El Paso County Park Advisory Board

Agenda Item Summary Form

Agenda Item Title: Sterling Ranch Sketch Plan Amendment #3 and Rezones

Agenda Date: September 13, 2023

**Sterling Ranch Sketch Plan
Amendment #3 Review**

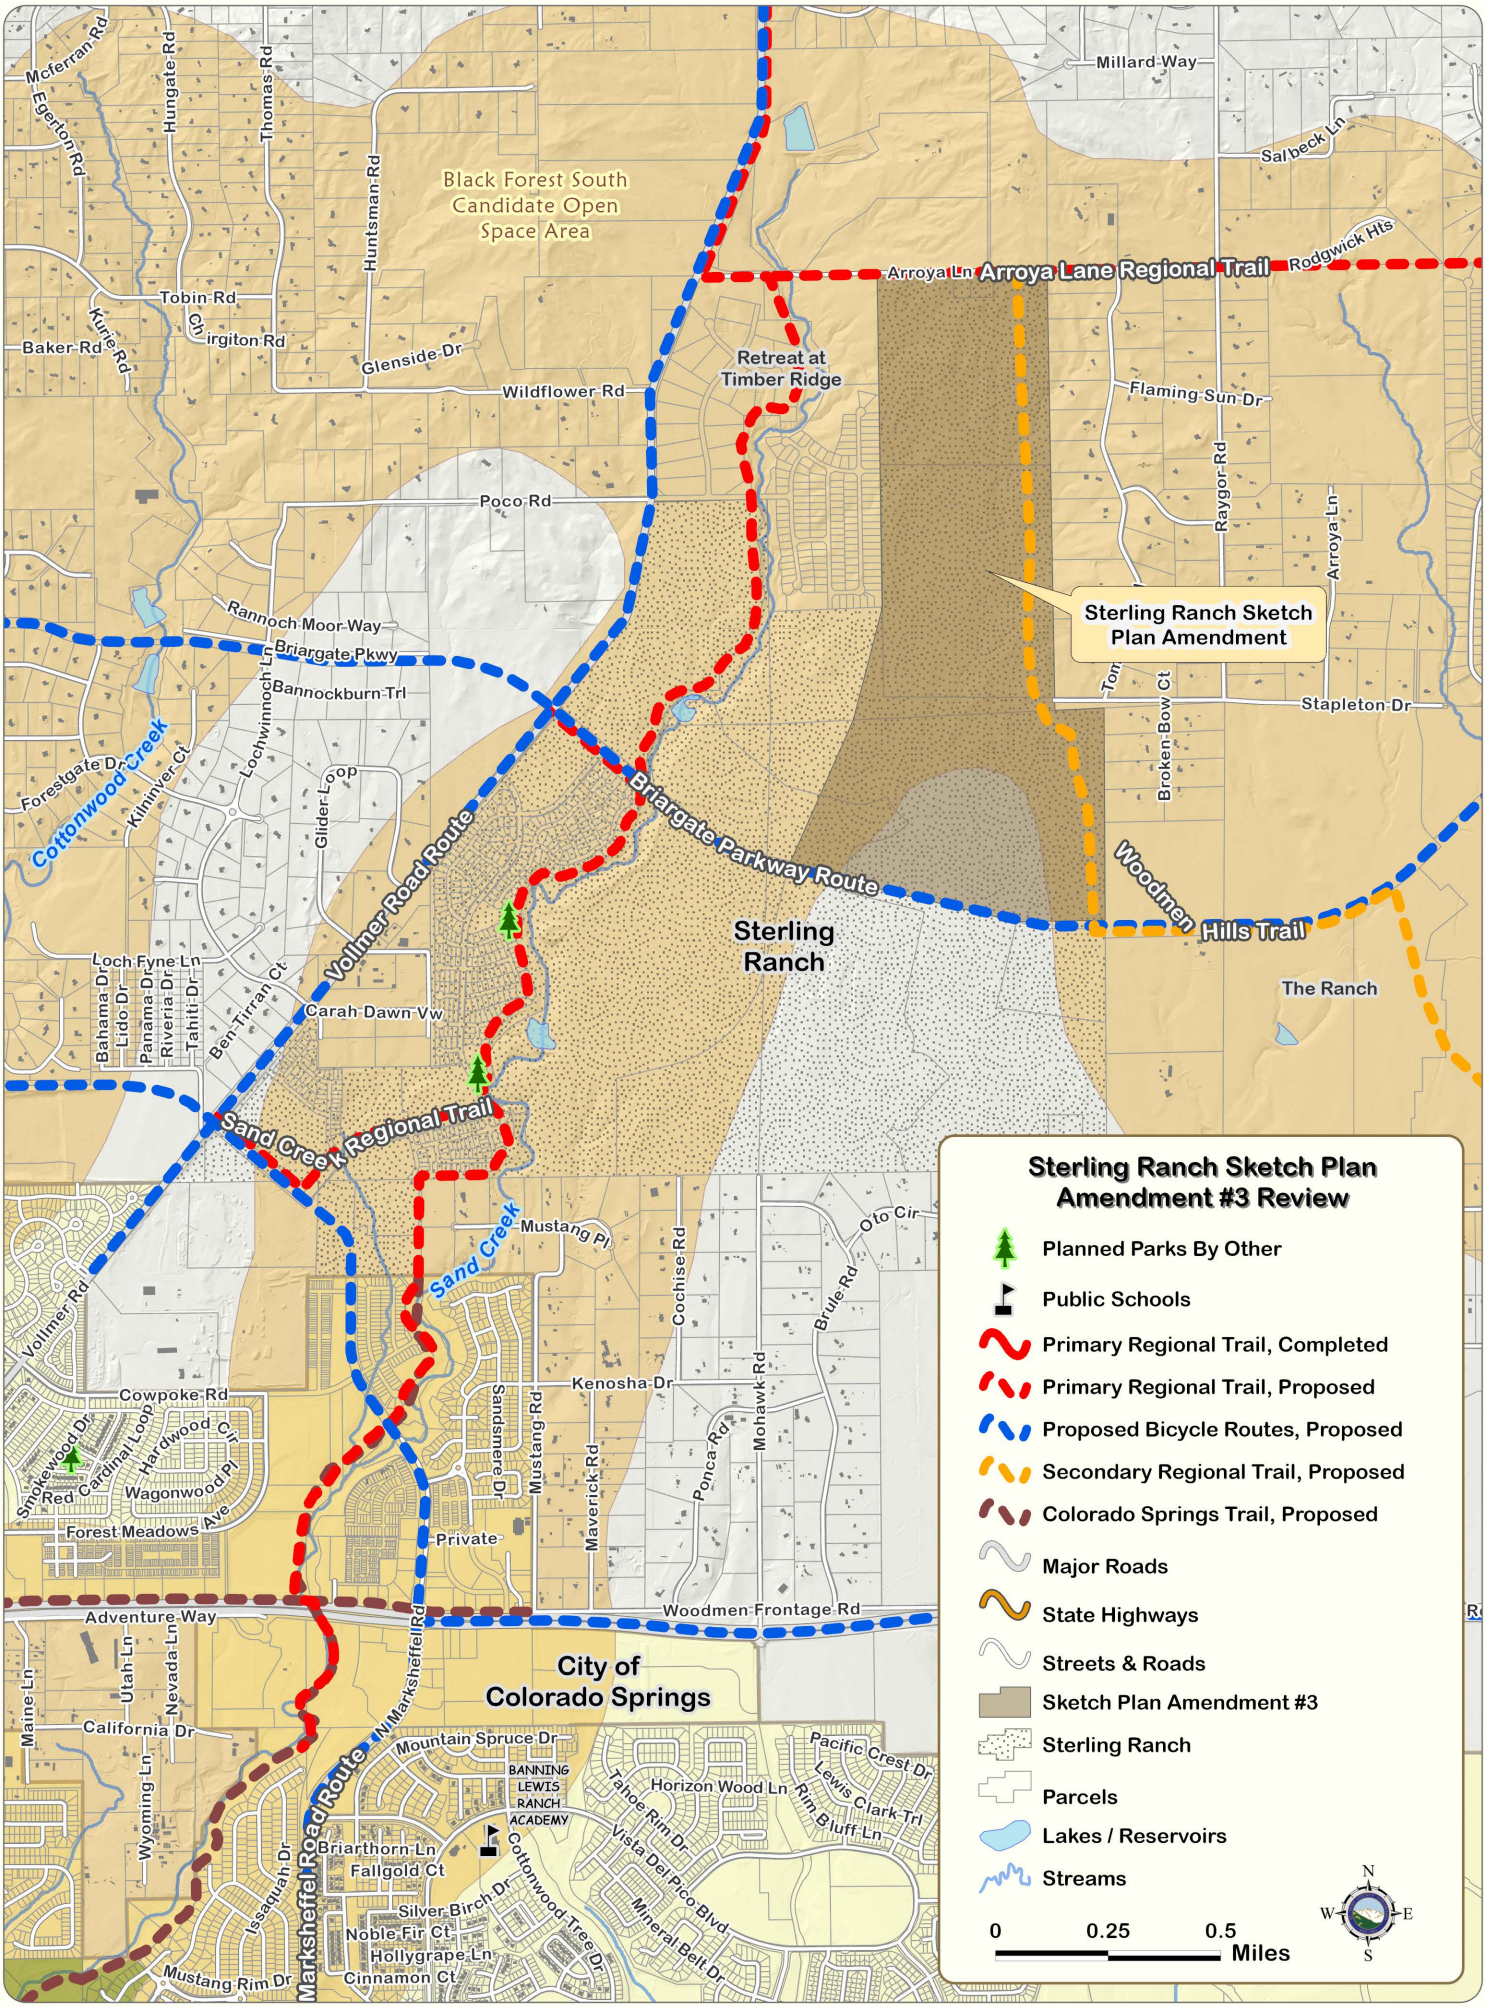
The 2022 El Paso County Parks Master Plan shows two proposed regional trail connections and one proposed bicycle route impacted by the project. The proposed Arroyo Lane Primary Regional Trail traverses east/west along the northern property boundary and will provide connectivity to Meridian Ranch to the east and the Sand Creek Regional Trail to the immediate west near the intersection of Arroyo Lane and Vollmer Road. The proposed Woodmen Hills Secondary Regional Trail runs north/south along the easternmost Sterling Ranch property boundary, making vital connections between the Sand Creek and Arroyo Lane Regional Trails in the north, Briargate Parkway to the south, and ultimately, the Rock Island Primary Regional Trail further south within the Town of Falcon.

Furthermore, the proposed Briargate Parkway Bicycle Route runs east/west adjacent to the southern side of the Sketch Plan Amendment. A dedicated public right-of-way already exists along the aforementioned bicycle route, so no easement requests are necessary at that location; however, the applicant is advised that multi-modal transportation options will be developed within the rights-of-way in the future, especially given the current development of the Briargate Parkway / Stapleton Road Corridor Study.

The Sketch Plan Amendment Letter of Intent highlights the 40-acre open space buffer along the eastern boundary of Sterling Ranch. The Woodmen Hills Secondary Regional Trail is located within this north-south trending open space area, which varies in width from 50' at its northern end to 250' near its intersection with Briargate Parkway. This open space buffer continues to the southeasternmost corner of Sterling Ranch as a location for a neighborhood trail and utilities. Additionally, the Sketch Plan includes a 25' trail corridor along Arroyo Lane to accommodate the Arroyo Lane Primary Regional Trail.

Staff is pleased the Sketch Plan Amendment contains a large percentage of park and open space areas, including the aforementioned 28-acre community park situated along Sand Creek, as well as numerous neighborhood parks, passive use areas, open spaces, and public trail corridors. Staff encourages the applicant to continue to develop park, trail, active-use area, and playground plans that provide a wide variety of recreational choices to users of all age groups and abilities.

Furthermore, staff encourages the developers to construct internal trail systems that link residents not only to the proposed neighborhood and community parks, schools, and businesses, but also to the County’s regional trail system. Lastly, staff recommends that the developers designate and provide to El Paso County 25-foot trail easements along the southern side of Arroyo Lane and through the eastern open space buffer for the purpose of public access, construction, and maintenance of the Arroyo Lane Primary Regional Trail and Woodmen Hills Secondary Regional Trail, respectively.

The Park Advisory Board recommends that the Planning Commission and the Board of County Commissioners include the following conditions when considering and/or approving Sterling Ranch Sketch Plan Amendment #3: (1) designate and provide to El Paso County a 25-foot trail easement along the south side of Arroyo Lane and adjacent water tanks that allows for public access, as well as construction and maintenance by El Paso County of the Arroyo Lane Primary Regional Trail, (2) designate and provide to El Paso County a 25-foot trail easement through the eastern open space buffer that allows for public access, as well as construction and maintenance by El Paso County of the Woodmen Hills Secondary Regional Trail, (3) the easements shall be shown on all forthcoming preliminary plans and final plats, and the aforementioned easements shall be dedicated to El Paso County on the forthcoming final plat(s), (4) fees in lieu of land dedication for regional and urban park purposes will be calculated upon review of forthcoming preliminary plans and final plats, and will be required at time of the recording of the forthcoming final plats. Park Lands Agreements may be an acceptable alternative to regional and urban park fees provided the agreements are approved by the County and executed prior to recording the forthcoming final plat(s).”
